Euro Arte Apparels Ltd. (Extension)

11 December 2023

1. Building Information

Observation 1: Lack of retrofitting material test report. (Extension Building)

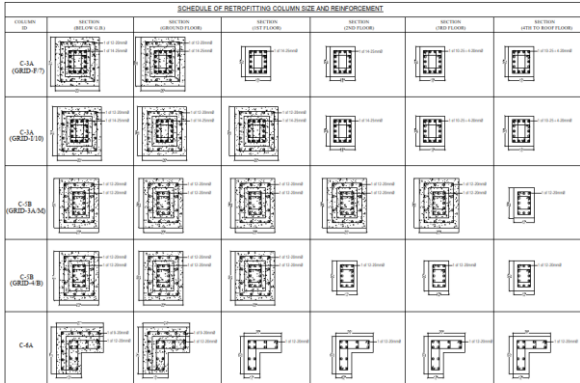
Retrofitted column schedule	Retrofitted column																																													
Description: The factory conducted retrofitting in column & foundation of the building in 2020. During inspection retrofitting material test report was not available. After completion of retrofitting works, the factory taken four concrete cores from existing columns. However, a Detail Engineering Assessment (DEA) report was available on site considering concrete strength 37.1 MPa for column based on core test report. The factory is required to verify the retrofitting material strength either from cylinder test report or by taking cores from retrofitted column/foundations and revise the design report accordingly.

SL	Observation	Action Plan	Timeline
01.	Lack of retrofitting material test report. (Extension Building). (Extension Building)	The factory is required to verify the retrofitting material strength either from cylinder test report or by taking cores from retrofitted column/foundations and revise the design report accordingly.	within 6 weeks

Observation-2: Mismatch in as-built drawing. (Extension Building)

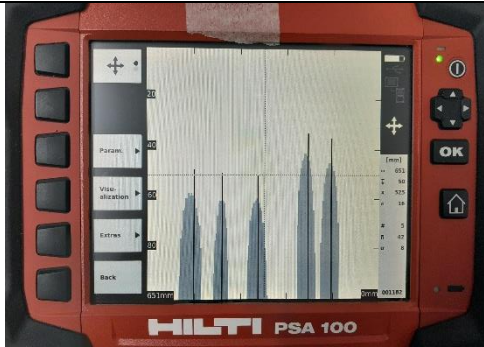
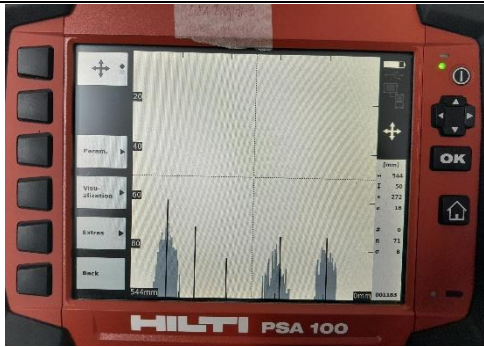
Description: During the inspection, rebar mismatch was found in C2 column. 16 rebars were found onsite instead of 18 rebars. The building engineer is required to survey the full structure and update the as-built drawing accordingly.

03.	Lack of retrofitting material test report. (Extension Building). (Extension Building)	Implement floor loading plan.	within 6 months
04	Mismatch in as-built drawing. (Extension Building)	The building engineer is required to survey the full structure and update the as-built drawing accordingly.	within 6 weeks
